VSP-35  
April 21, 1982

Global Navigation Service Bulletin No. 21  
(Highly recommends modification to the  
battery charging card which is installed in  
Optional Equipment Unit P/N 10600-2-2XX.)

## MODIFICATION OF BATTERY CHARGING CARD P/N 11745-1

Number 0021

Figure 1 (Sheet 1)

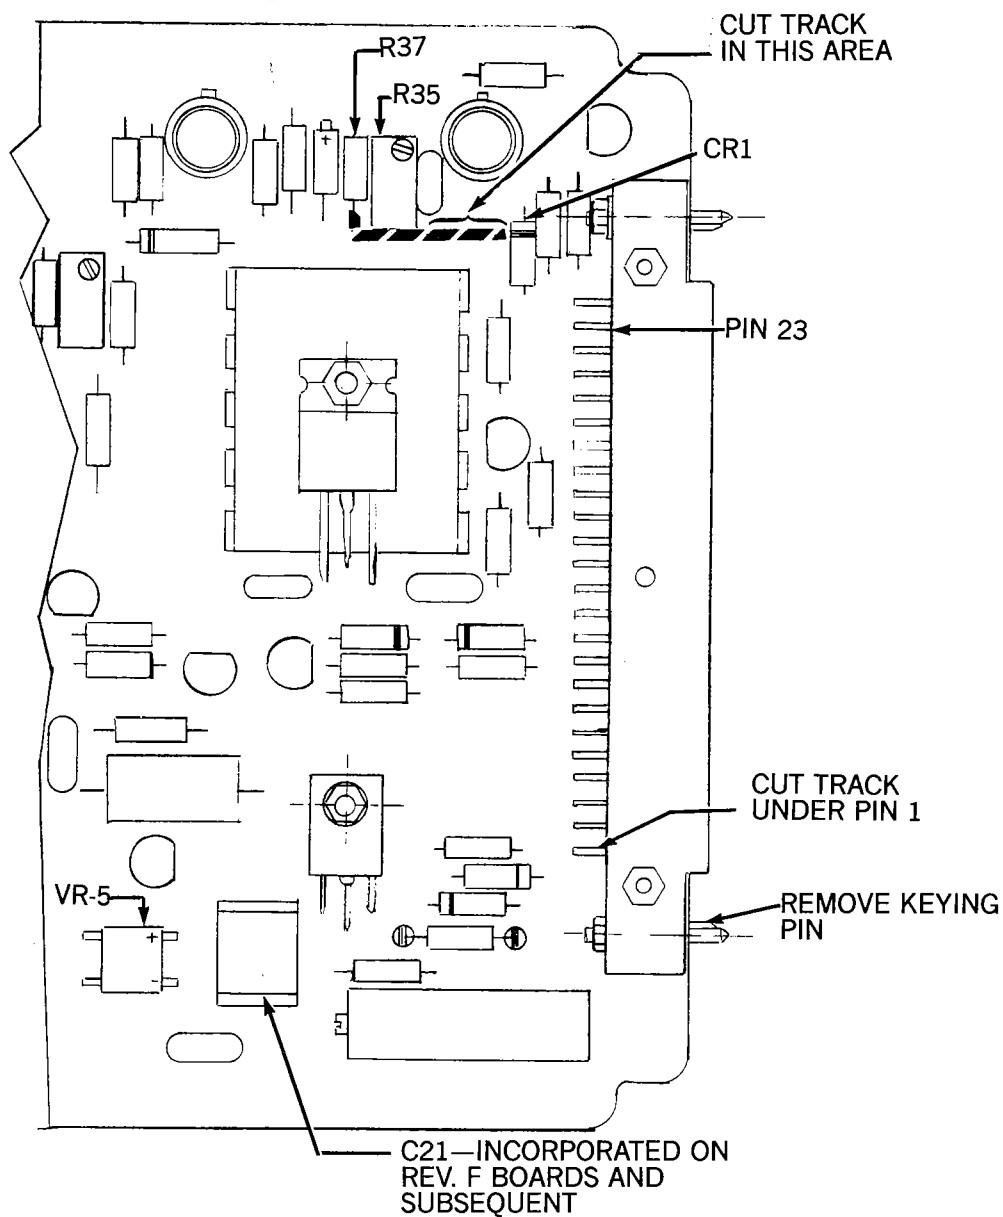
There have been two verified service failures of battery charging card P/N 11745-1 in which the card overheated. Global has identified the cause and is modifying all P/N 11745-1 boards in stock and in service through a field modification program.

- (1) Remove top cover from OEU P/N 10600-2-2XX.
- (2) Remove battery charging card P/N 11745-1 from Slot J2 in OEU.
- (3) Perform the following impedance check using a digital multimeter with a minimum input impedance of 10 Megohms.
  - (a) Connect positive lead to Pin 1 on connector. See Figure 1 (Sheet 1).
  - (b) Connect negative lead to Pin 24 (ground). See Figure 2.

- (c) Check potentiometer R35 for resistance value. Resistance value may either be 20K ohms or 2K ohms. See Figure 1 (Sheet 1).

- (4) Remove keying pin from connector at end adjacent to Pin 1. See Figure 1 (Sheets 1 and 2).

- (5) Cut tracks at location A (under Pin 1) and at location B (on track near R37) with an Exacto knife or equivalent. See Figure 1 (Sheets 1 and 2).

- (7) Perform continuity check between the following and verify that the circuit is open. See Figure 1.

NOTE: In cutting the track at least 0.050 inch of track should be removed at each location.

(a) Pin 1 on connector and R37.

(b) Pin 23 on connector and negative terminal on VR-5.

Figure 2

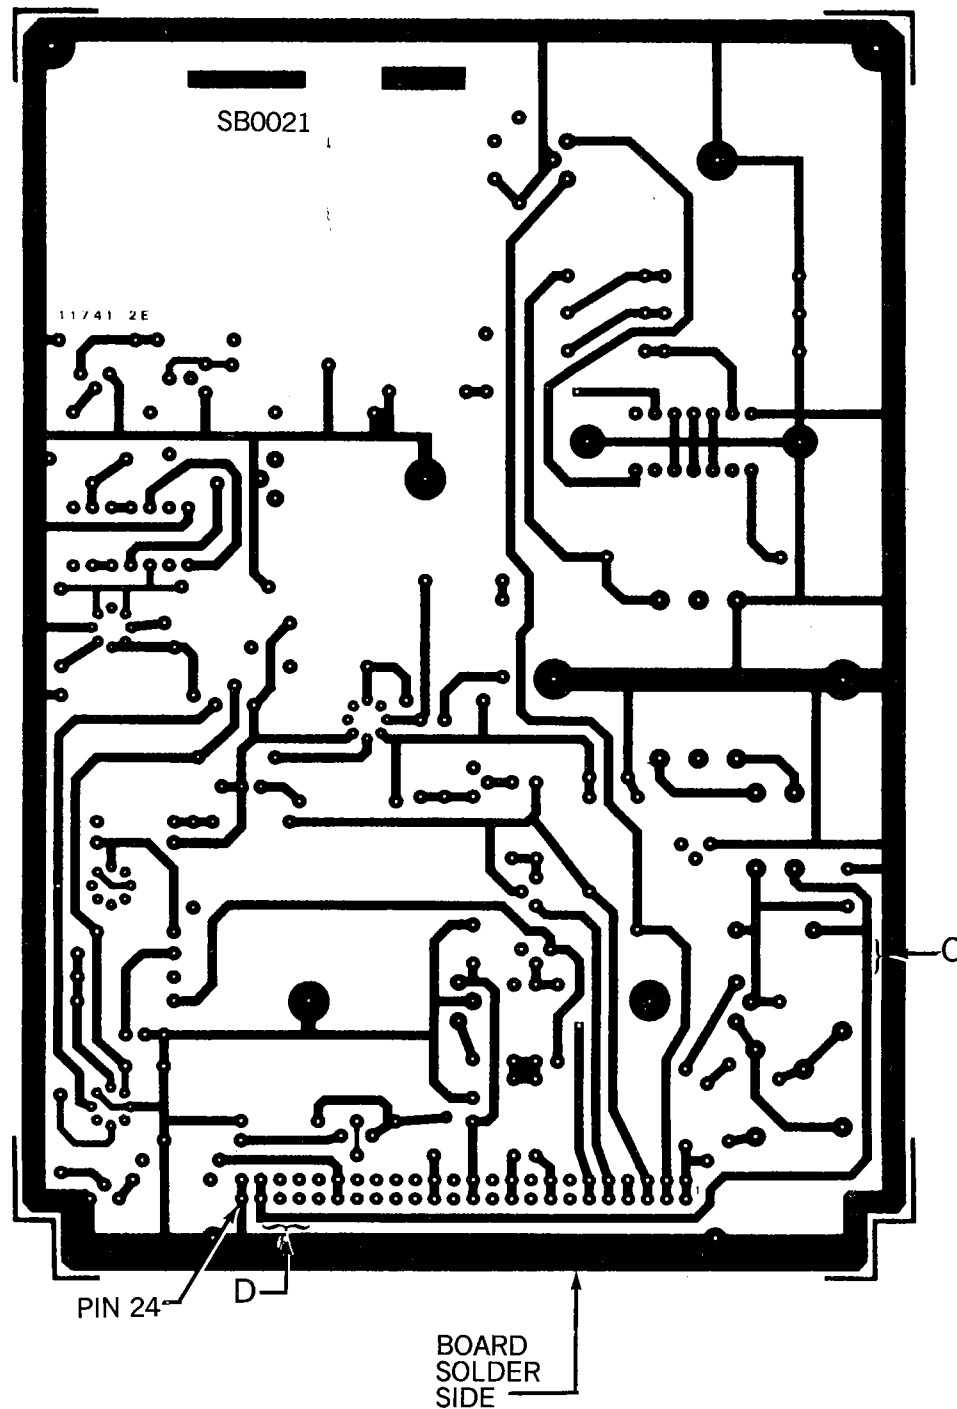
- (6) On solder side of board, cut tracks at locations C and D, removing at least 0.050 inch of track at each location. See Figure 2.

Figure 3

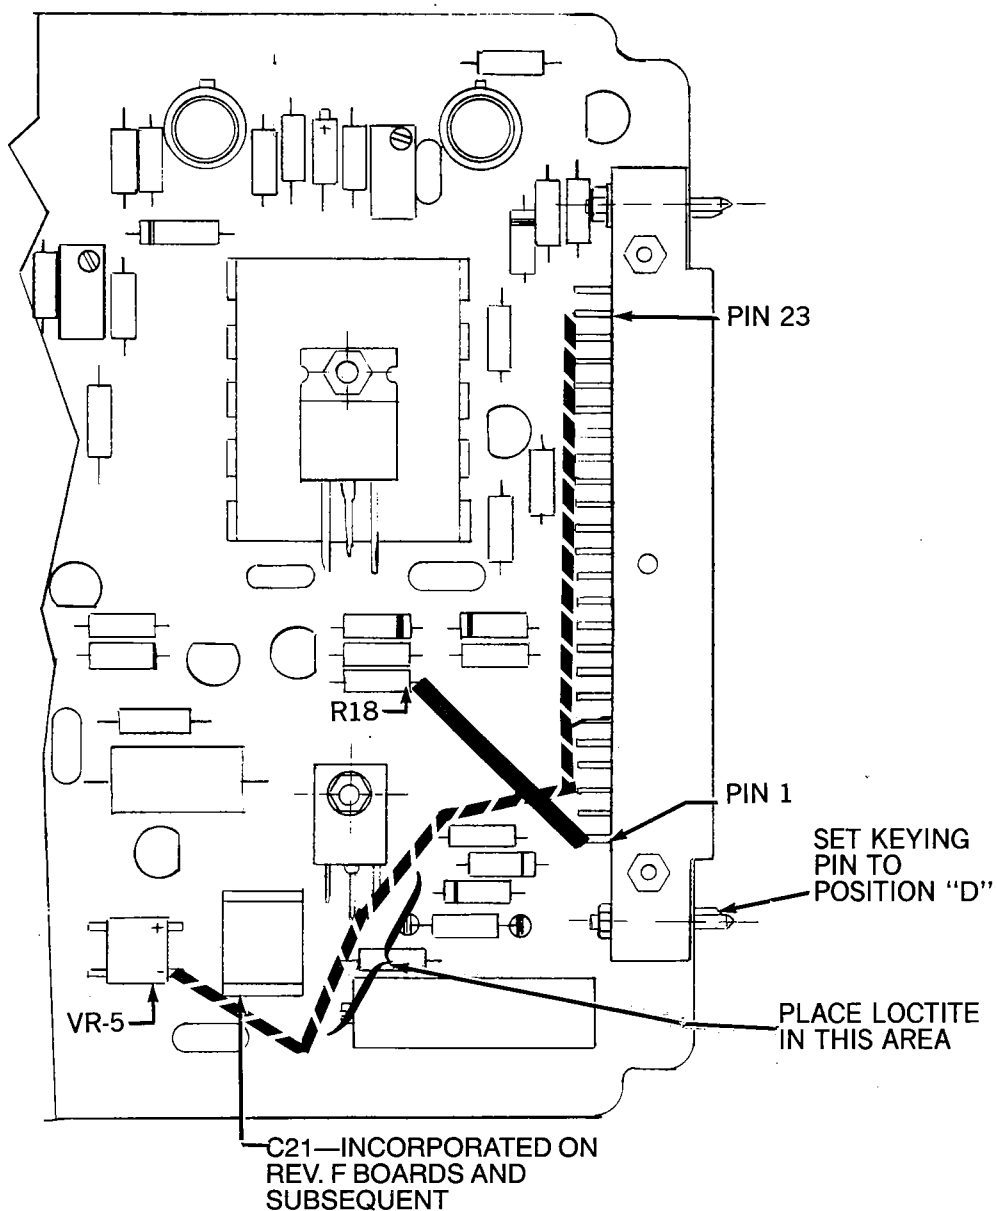
- (8) Solder a 4 inch, 22 gage bus wire covered with teflon sleeving between Pin 23 and negative terminal on VR-5. Trim and dress wire to look neat. See Figure 3.

- (9) Solder a 1.25 inch 22 gage bus wire covered with teflon sleeving between Pin 1 on connector and resistor R18. Trim and dress wire to look neat. See Figure 3.

NOTE: A solid conductor, 22 gage teflon wire may be substituted for sleeved 22 gage bus wire.
